Dewberry Response to USGS Review of the TX Red River Atascosa Lidar Project

Produced for U.S. Geological Survey

USGS Contract: G16PC00020

Task Order: G17PD00014

Figure 2-Tile 14RMS905965. The image on the left is an overview of the DEM where USGS made a bridge call. The image on the right is an overview of the DEM after Dewberry reclassified the bridge from ground to bridge deck.

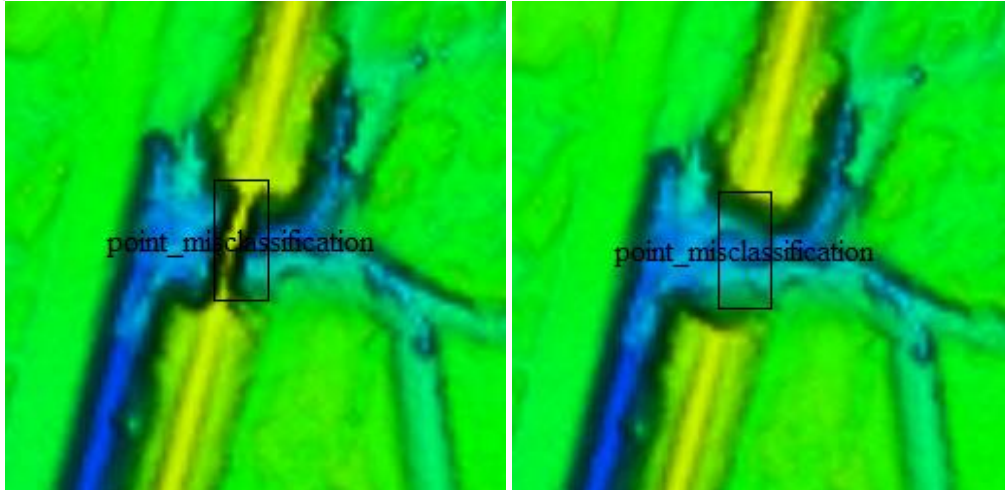
USGS identified four (4) bridges as being left in the ground model. Dewberry has reclassified the bridges to Class 17 Bridge Deck Class.

Figure 3- Tile 14RNS475770. The image on the left is an overview of the DEM where USGS made a call where there was an erroneous change in elevation between the waterbody and ground. The image on the right is an overview of the DEM after Dewberry adjusted the DEM to better represent the terrain.

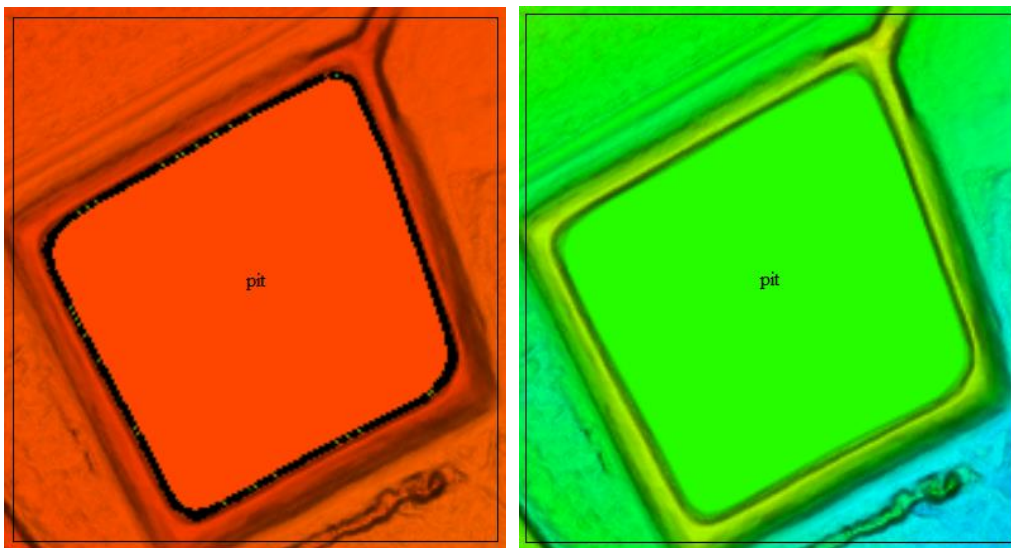
USGS made three (3) hydro calls where there was an erroneous change in elevation between the waterbody and ground. Dewberry adjusted the DEM to better represent the terrain.

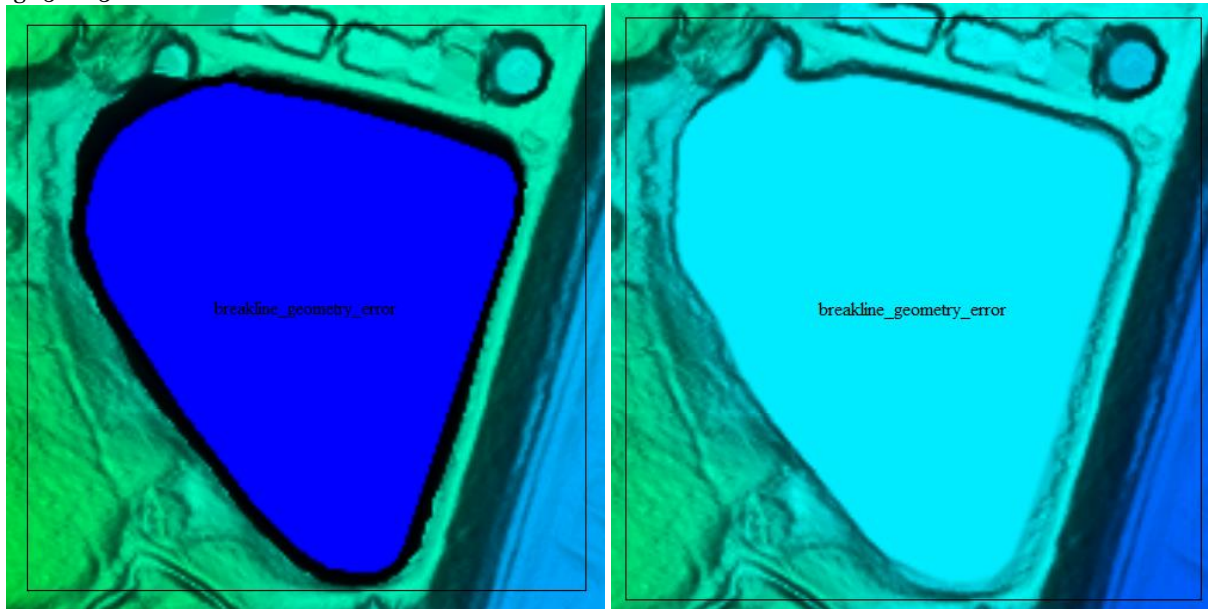
There is one (1) location where Dewberry flattened a hydrographic feature excessively. USGS identified this feature and asked that it be raised so as to more accurately portray the water surface. Dewberry agrees and it has been corrected. An example is shown below.

Figure 4- Tiles 14RNT100445 and 14RNT100460. The pond on the left was identified by USGS as an excessively digging hydrographic feature that needs to be raised to better portray the actual elevation of the water. The LAS and DEM have been corrected by changing the breakline elevations, shown on the right.

Figure 5- Tile 14RPS360410. The pond in the center of the image was identified by USGS as needing to be hydroflattened. The LAS, breaklines, and DEM have been corrected, shown below.

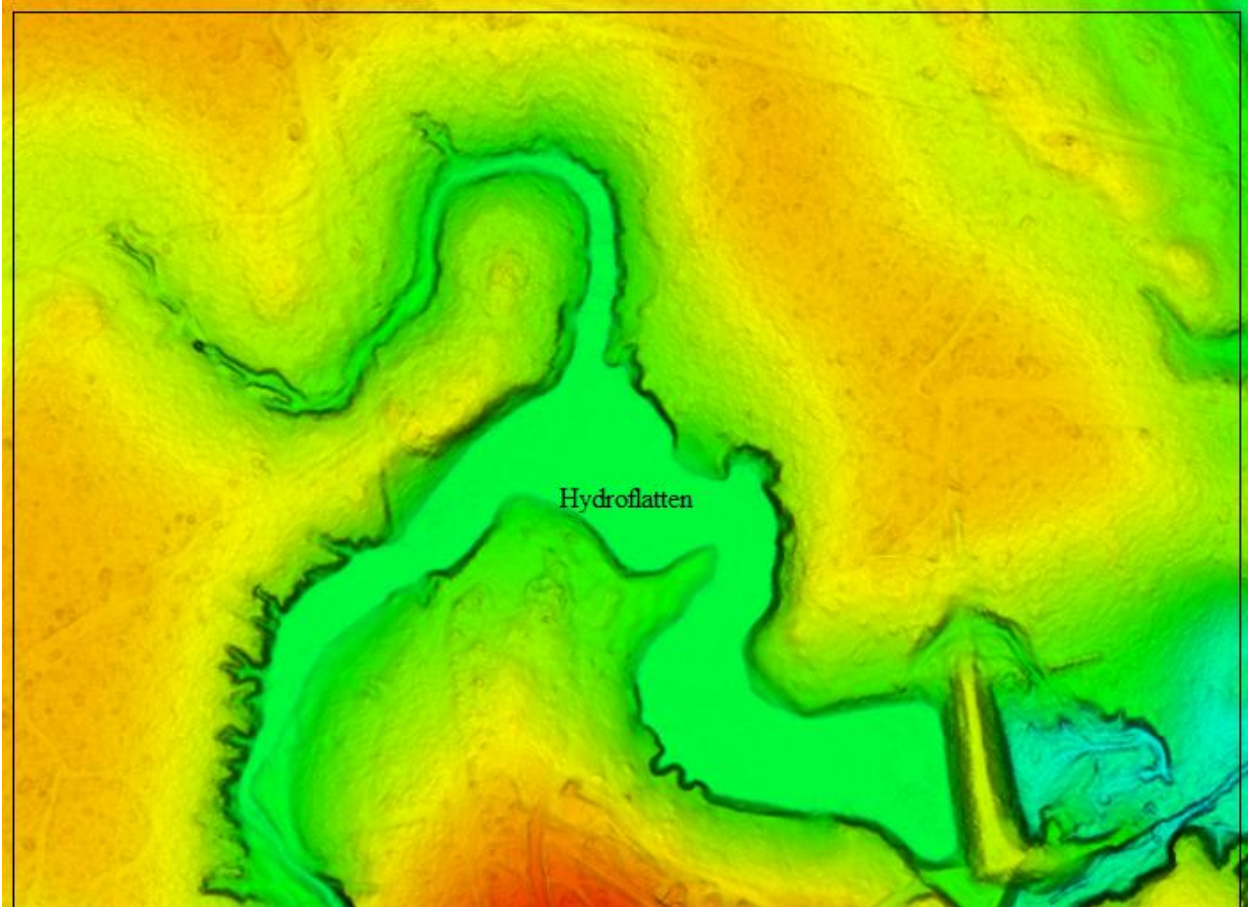
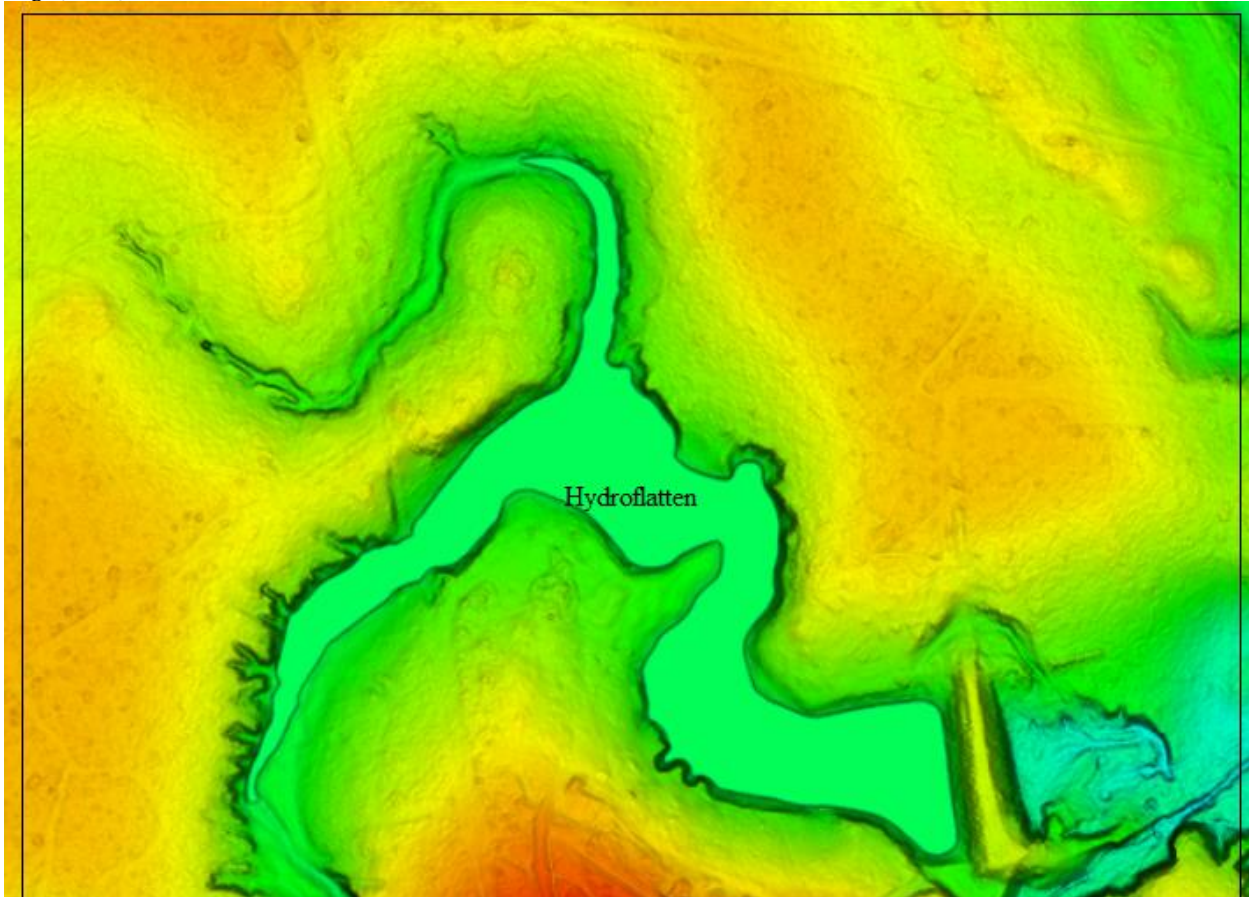
USGS identified five (5) hydro-flattening errors. The edit calls were reviewed and the breaklines, LAS, and DEMs were corrected. An example is shown below.

Figure 6- Tile 14RPS360410. The breaklines have been corrected to include the waterbody; the LAS and DEM were updated accordingly.

Figure 7- Tile 14RNS385875. The waterbodies in the center of the image were identified by USGS as not accurately representing the terrain. The LAS, breaklines, and DEM have been corrected, shown below.

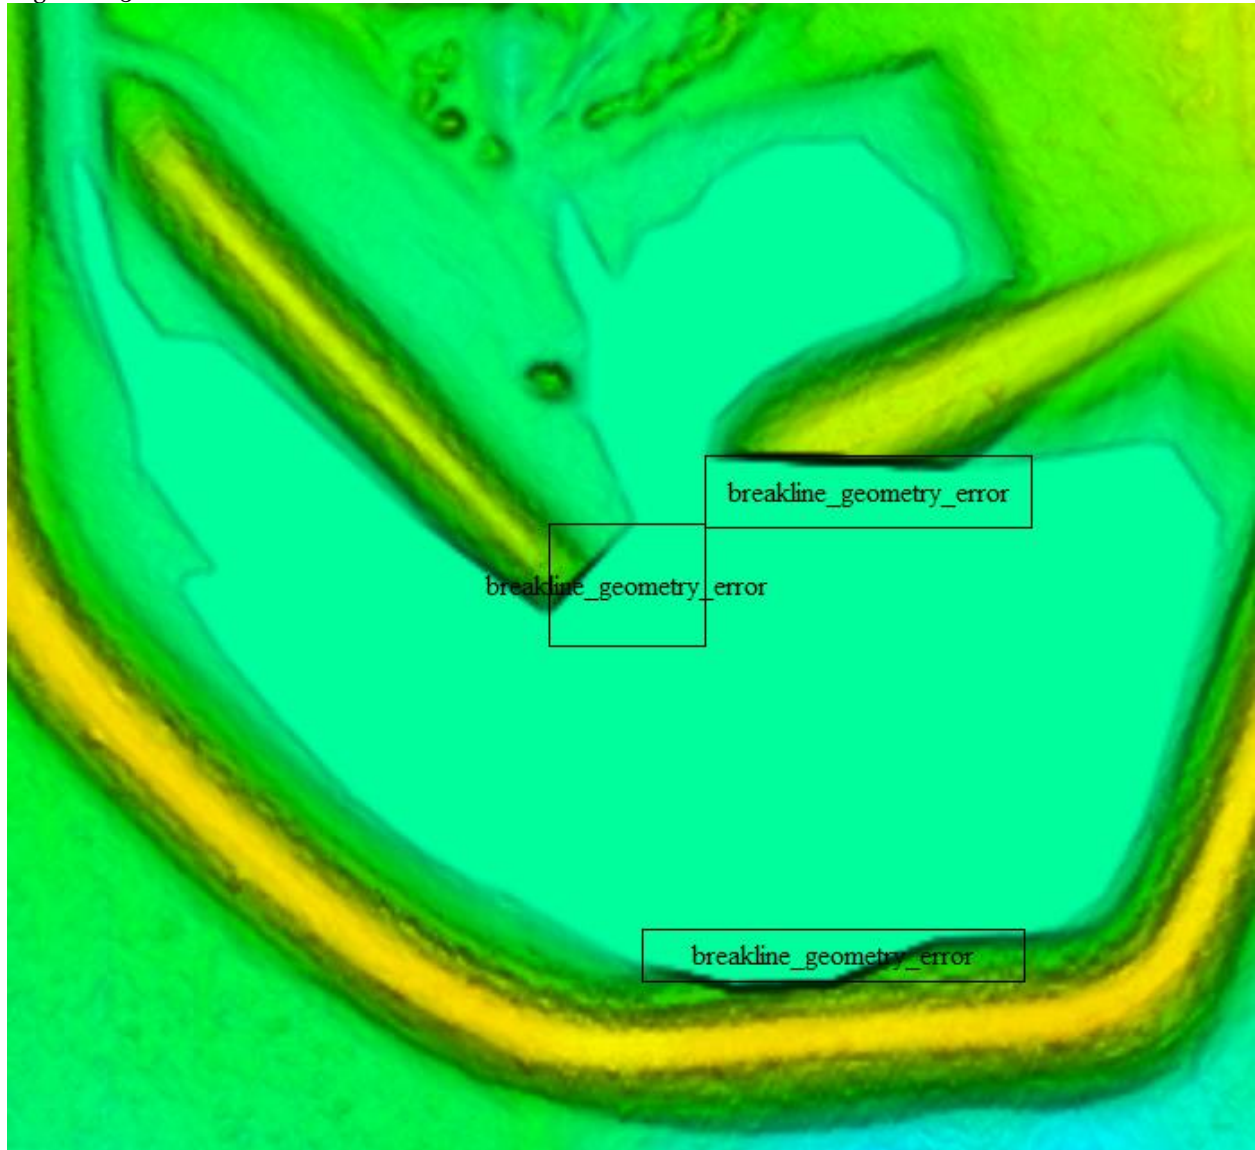
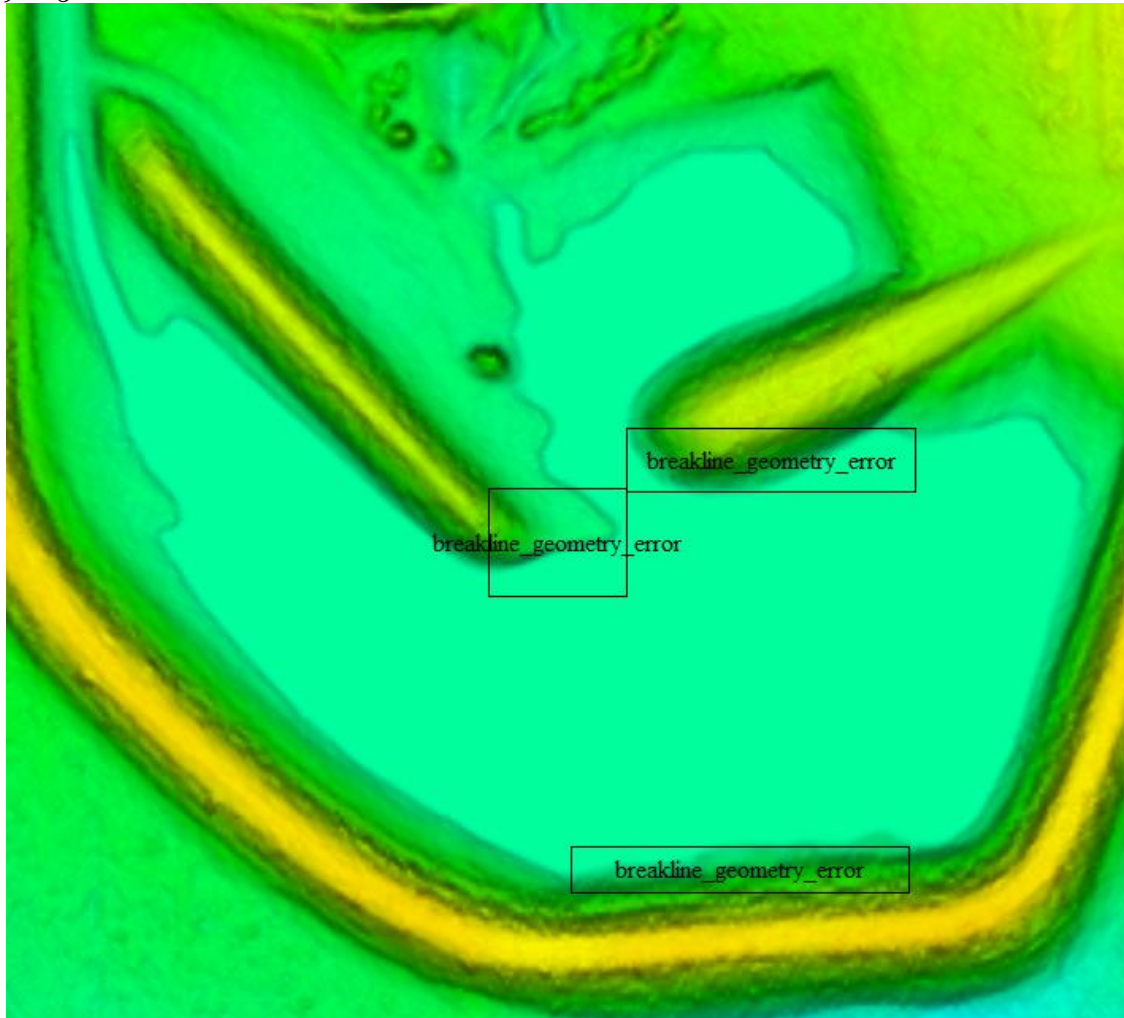
USGS identified five (5) issues where waterbodies did not accurately represent the terrain. The edit calls were reviewed and the breaklines, LAS, and DEMs were corrected. An example is shown below.

Figure 8- Tile 14RNS385875. The breaklines have been corrected to accurately represent the terrain; the LAS and DEM were updated accordingly.

Figure 9- Tile 14RNS910800. The image on the left was identified by USGS as not being clipped to the project boundary. The DEM has been clipped to the project boundary, as shown in the image on the right.

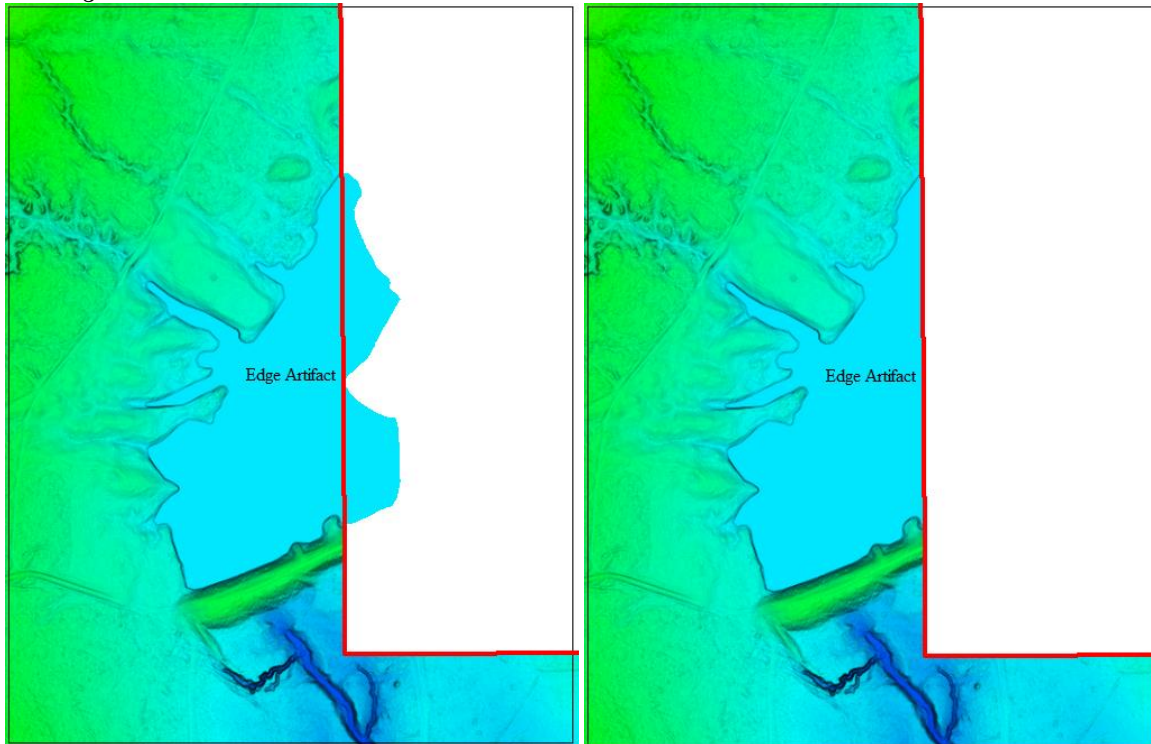
USGS made two (2) calls of areas that were not clipped to the project boundary. The edit calls were reviewed and the DEMs were corrected. An example is shown below.

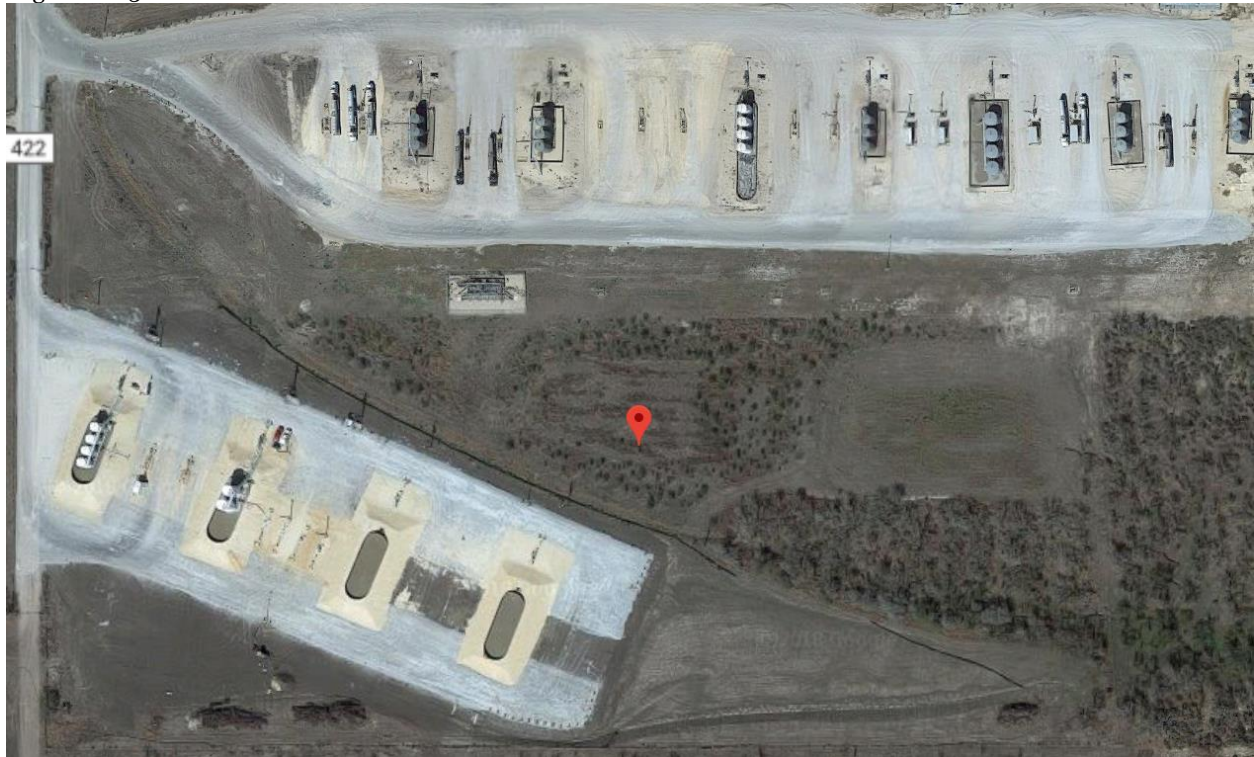
USGS made one (1) call for removal of structures. The edit calls were reviewed and Dewberry has determined that the structures are part of the ground and therefore not removed. An example is shown below.

Figure 10- Tile 14RNS775470. DEM is shown in the top image, lidar profile of ground (orange) points is shown in the middle image, and base imagery is shown in the bottom image. These features appear to be earthen mounds or foundations. The elevation change of the in-ground features are accurately portrayed in the DEM.
